Illinois Department of Transportation

SUBJECT: FAI Route 90 (I-90)
Project NHPP-V4UD(632)
Section (1517 & 1415)I-14
Cook County
Contract No. 60Y40
Item No. 5, June 15, 2018 Letting
Addendum A

NOTICE TO PROSPECTIVE BIDDERS:

VINE PLANTING DETAIL (not to scale)

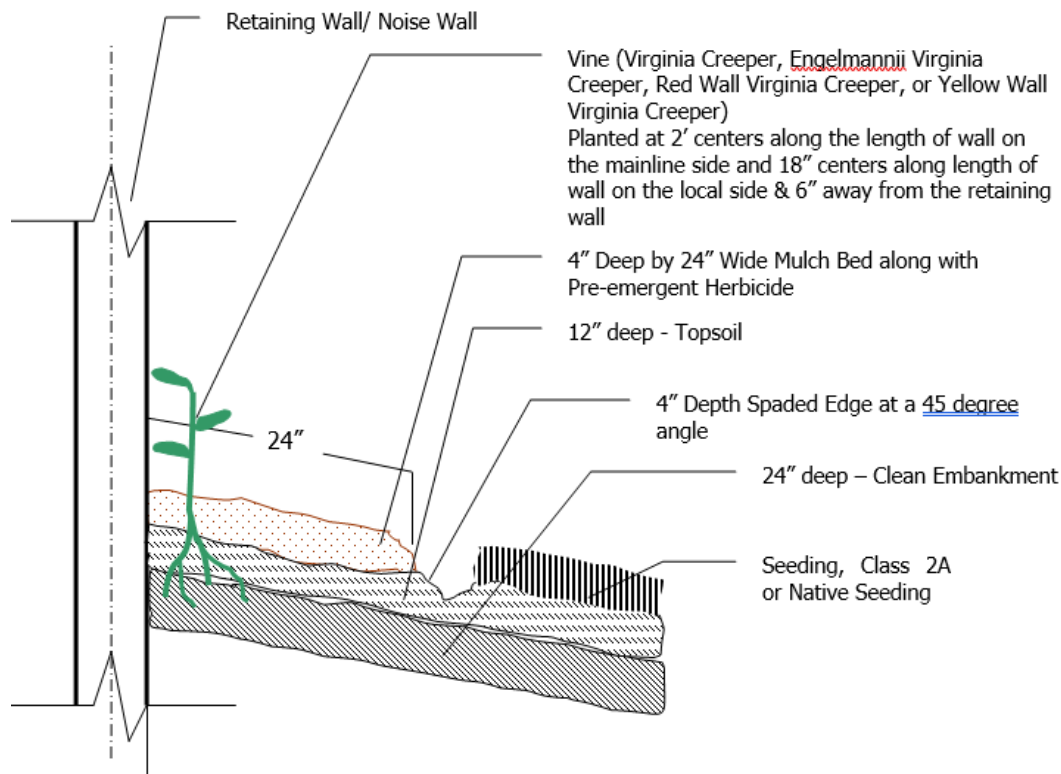
A significant lead time (up to or exceeding 12-months) is anticipated for the vines to be available for installation once procured/ordered.

The Contractor shall plant the vines according to the vine detail below.
